ADDENDUM NUMBER 1

PROJECT: 46 KV Transmission Line – 2024 Modifications & Additions
City of Fairhope (**BID NO. 25-003**)

FROM: Stewart Engineering, Inc.
PO Box 2233
Anniston, AL 36202
(256) 237-0891

2. **DRAWING NO. AX23103-1 – Sheets 1, 6, 7, 11, 12, 13, & 14**

CITY OF FAIRHOPE	
46KV TRANSMISSION LINE - 2024	
MODIFICATIONS & ADDITIONS ALTERNATE #1	
DRAWN BY: ACG	DATE: 10-10-24
APPROVED BY: JLJ	DATE: 10-10-24
DWG#: AX23103-1	STEWART ENGINEERING
SHEET: 6 OF 15	ELECTRICAL CONSULTANTS
SCALE: 1"=50'	ANNISTON, ALABAMA
	PHONE: (256)237-0891

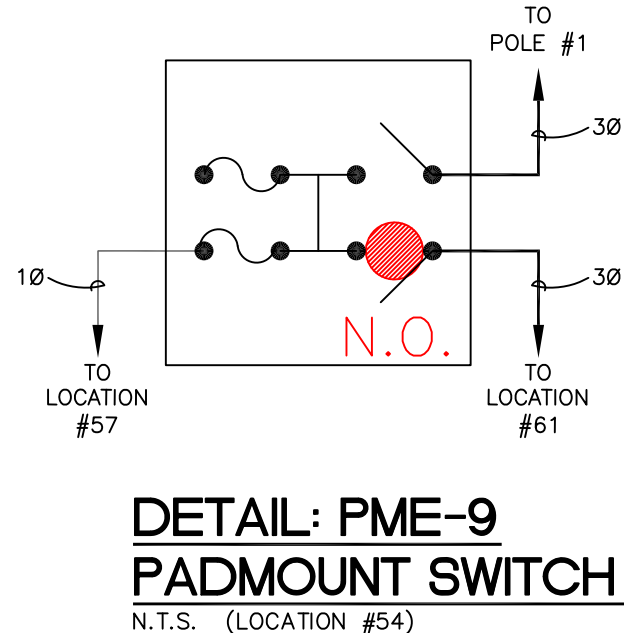
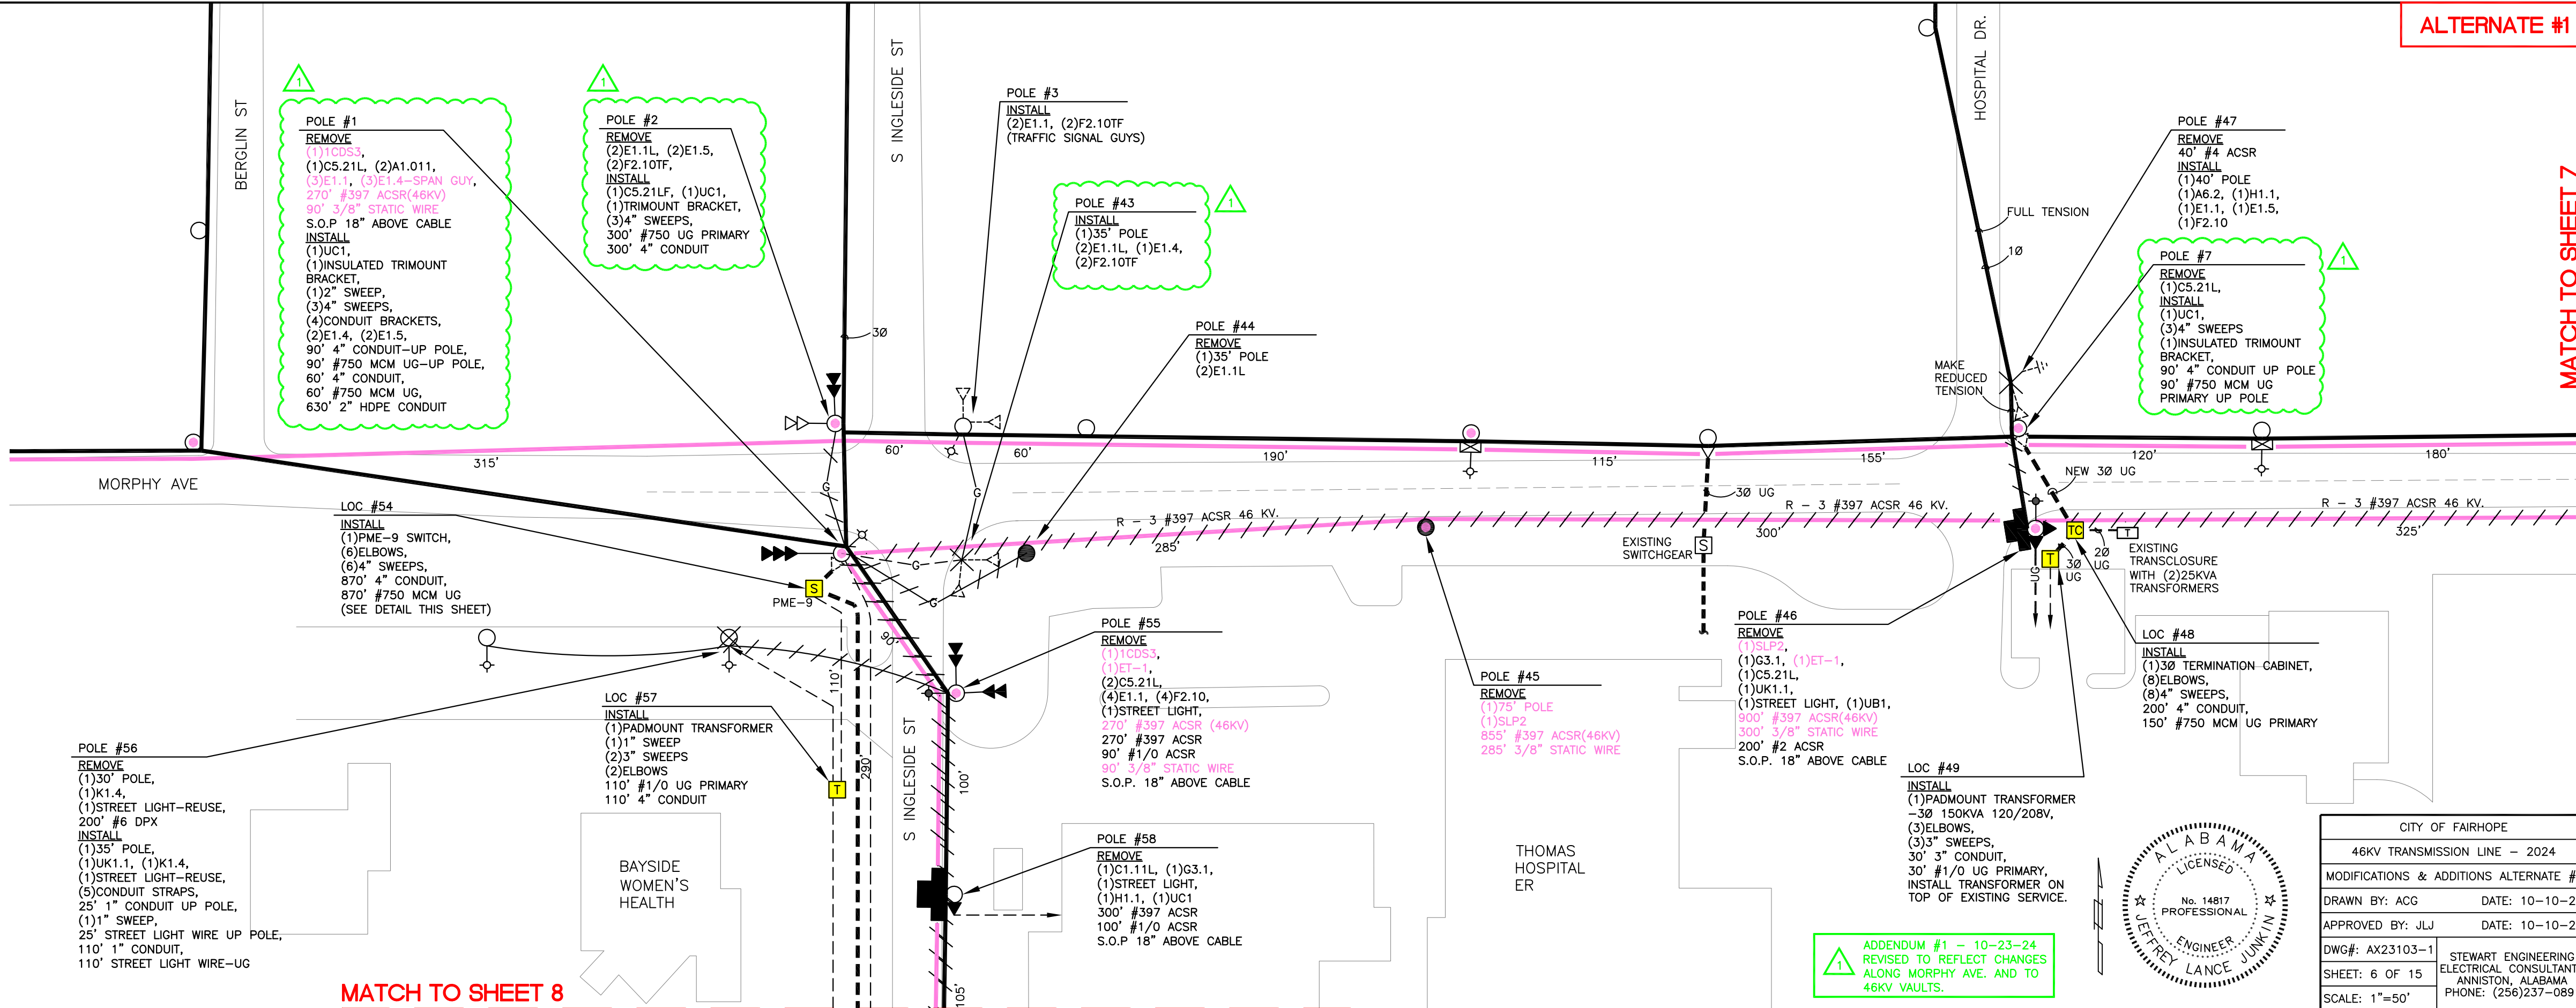
ADDENDUM #1 - 10-23-24
REVISED TO REFLECT CHANGES
ALONG MORPHY AVE. AND TO
46KV VAULTS.

CITY OF FAIRHOPE	
46KV TRANSMISSION LINE - 2024	
MODIFICATIONS & ADDITIONS ALTERNATE #	
DRAWN BY: ACG	DATE: 10-10-24
APPROVED BY: JLJ	DATE: 10-10-24
DWG#: AX23103-1	STEWART ENGINEERING ELECTRICAL CONSULTANT ANNISTON, ALABAMA PHONE: (256)237-089
SHEET: 7 OF 15	
SCALE: 1"=50'

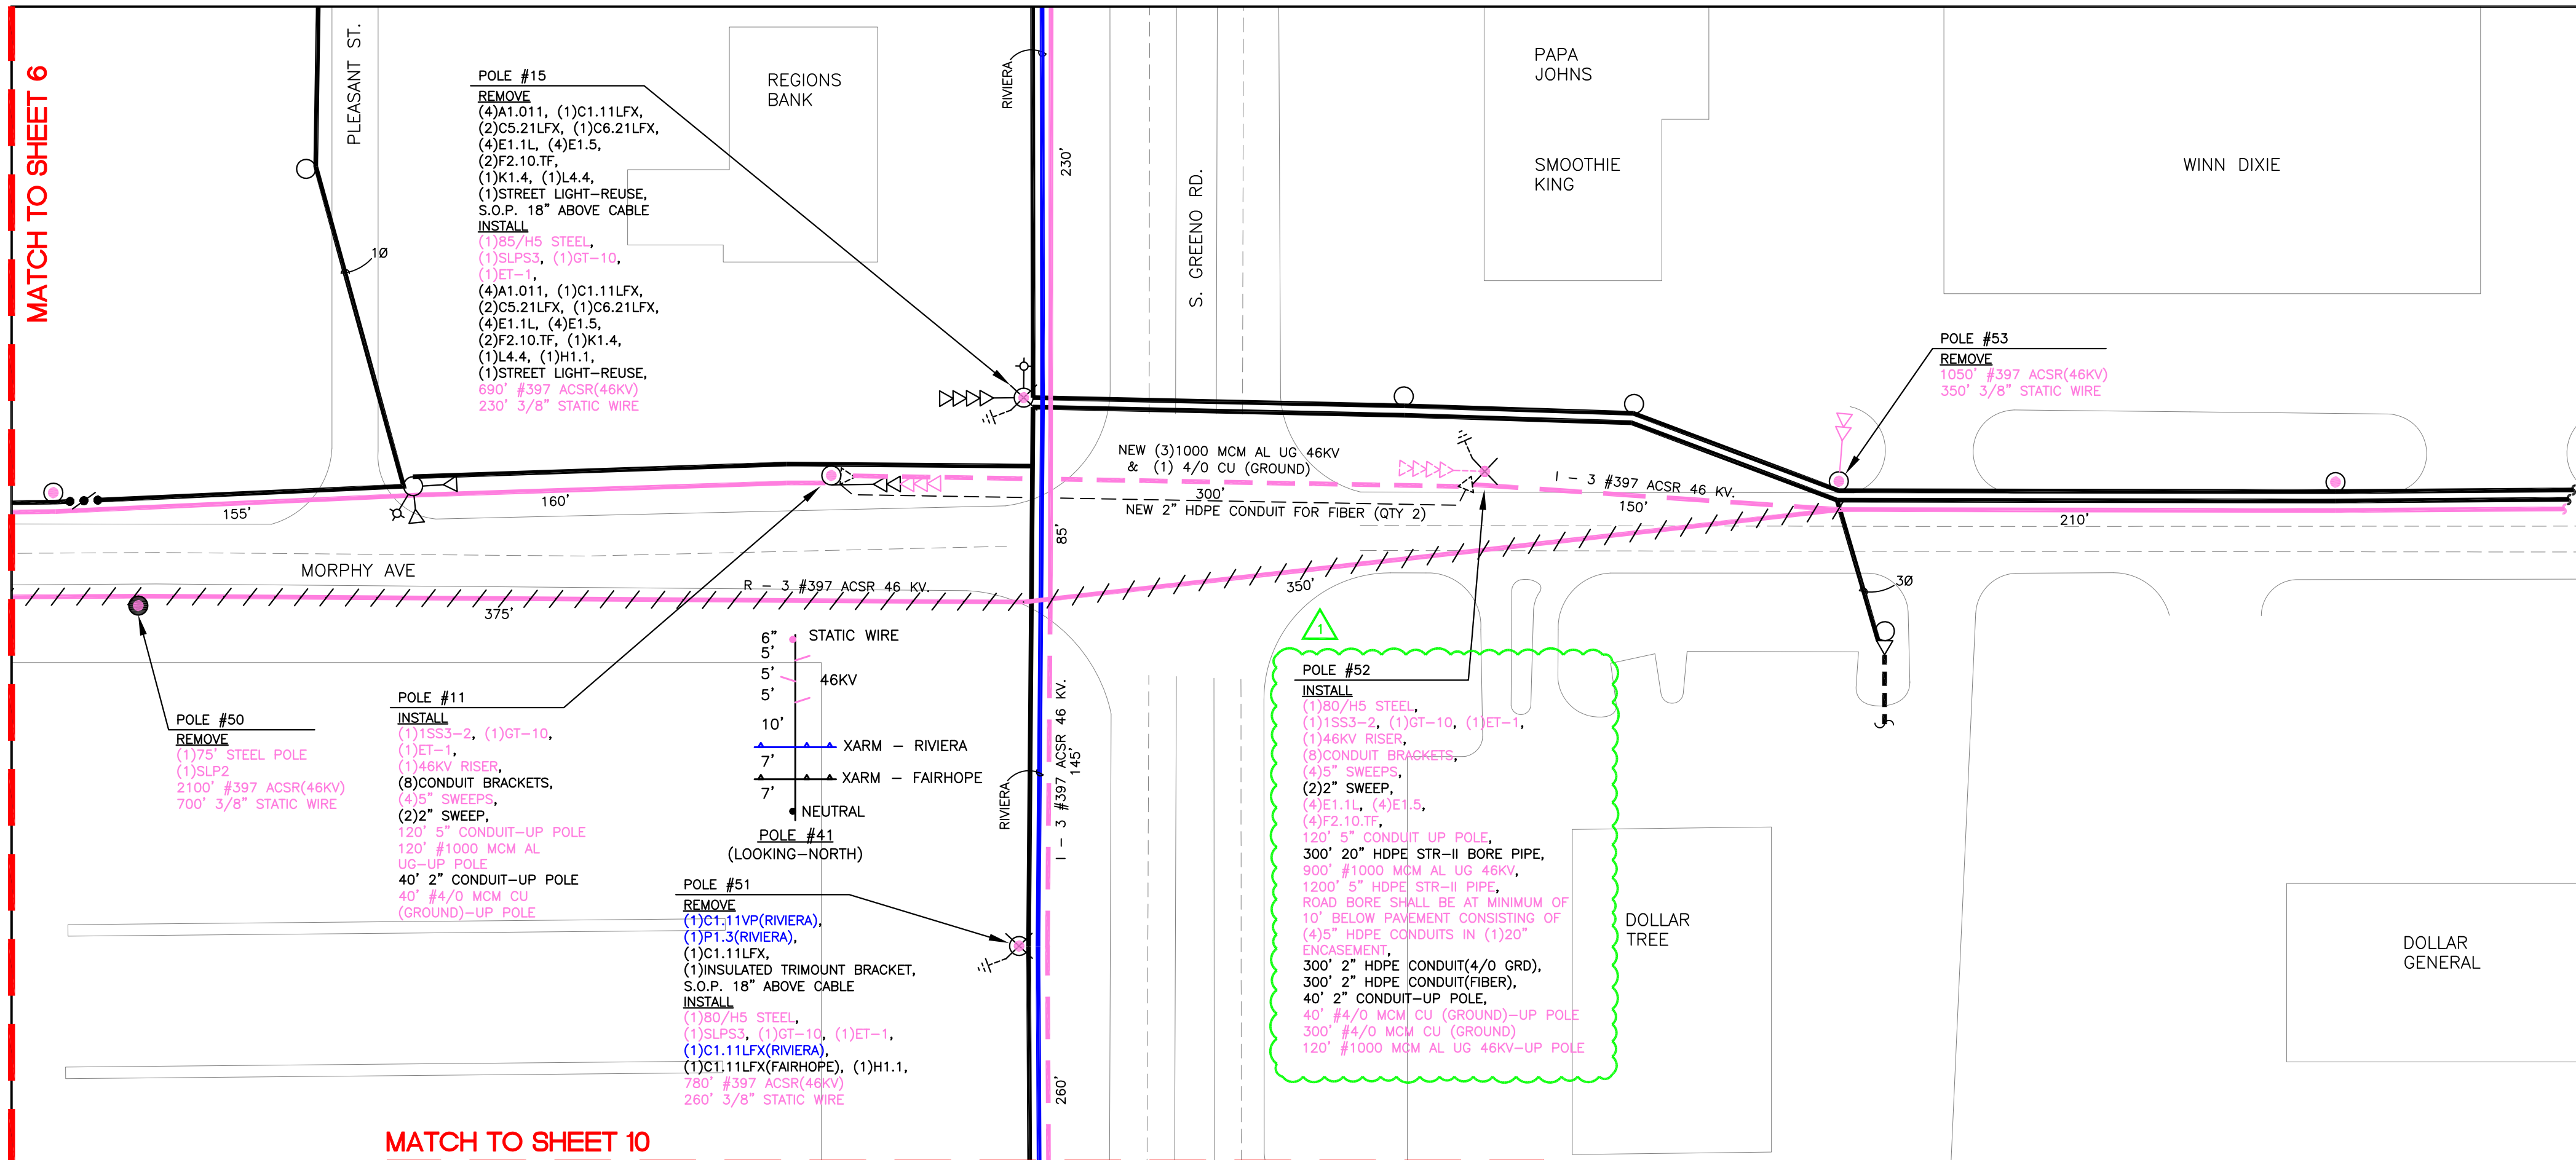
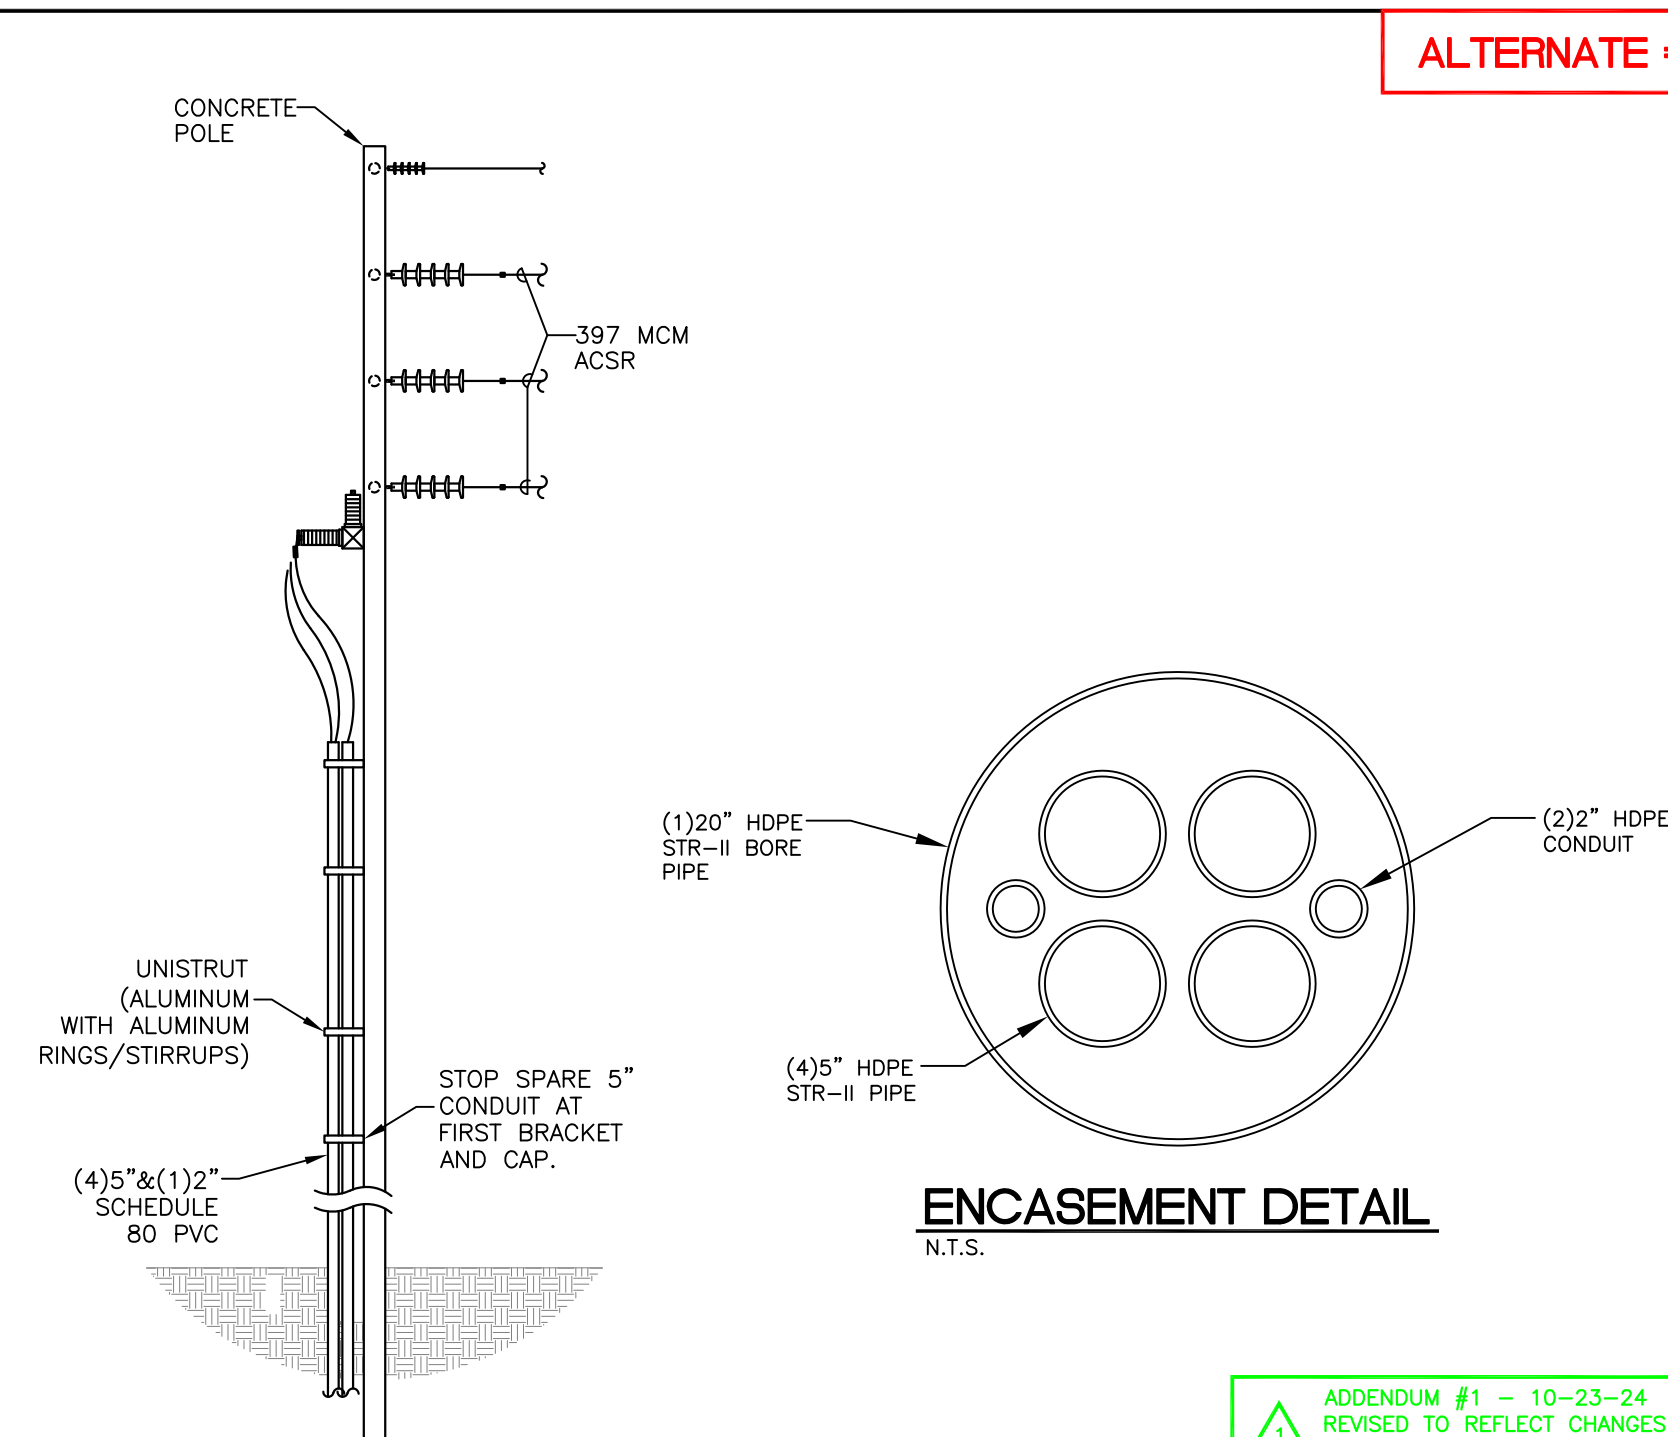
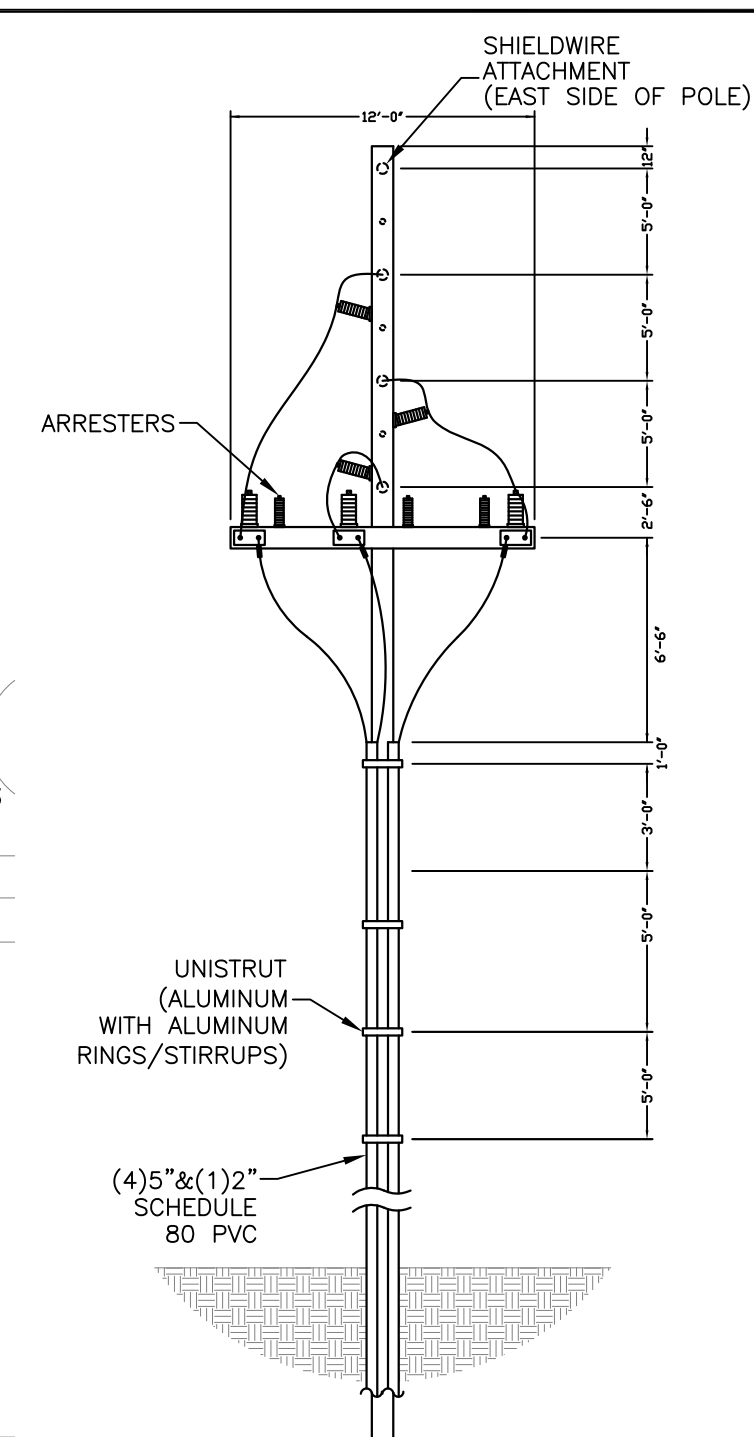
ADDENDUM #1 – 10-23-24
REVISED TO REFLECT CHANGES
ALONG MORPHY AVE. AND TO
46KV VAULTS.

CITY OF FAIRHOPE	
46KV TRANSMISSION LINE - 2024	
MODIFICATIONS & ADDITIONS ALTERNATE #2	
DRAWN BY: ACG	DATE: 10-10-24
APPROVED BY: JLJ	DATE: 10-10-24
DWG#: AX23103-1	STEWART ENGINEERING
SHEET: 12 OF 15	ELECTRICAL CONSULTANTS
SCALE: 1"=50'	ANNISTON, ALABAMA
	PHONE: (256)237-0891

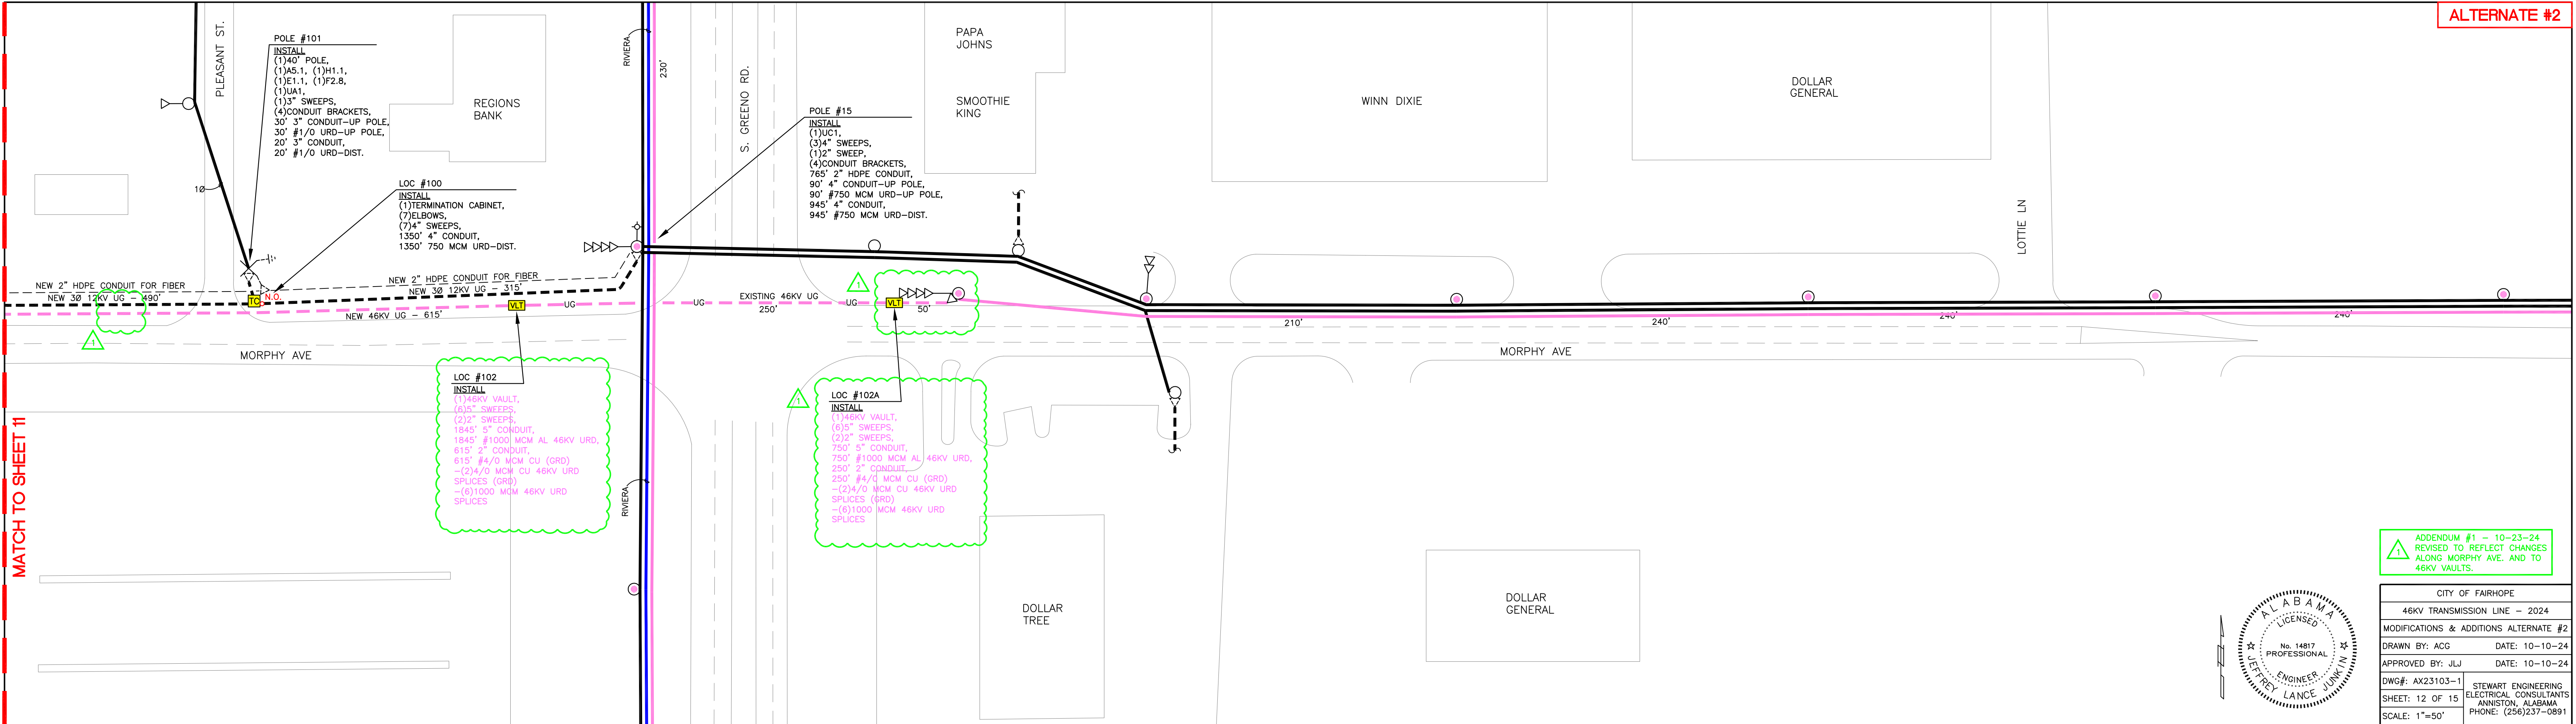
ADDENDUM #1 - 10-23-24
REVISED TO REFLECT CHANGES
ALONG MORPHY AVE. AND TO
46KV VAULTS.
